Access Compliance Report Public Rights-of-Way (Pedestrian Signals)

Main Street: MOUNTAIN_VIEW_AVE Cross Street: KELLOGG_DR Location: S

ADA ID: SGAT210922121621 Signal Type: One Push Button-Non APS Overall Compliance: No Severity Scores: BTN 1: 35 BTN 2: N/A No BTN: N/A

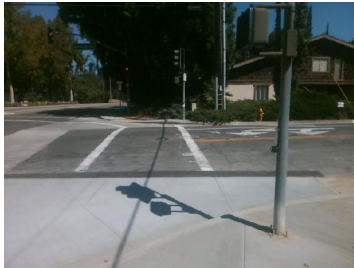
OC Std/PROW: R404.2, R404.3, MUTCD 4e.08

Possible Solutions: Replace Signal Push Button With APS Button. Remove and Replace Clear Space.
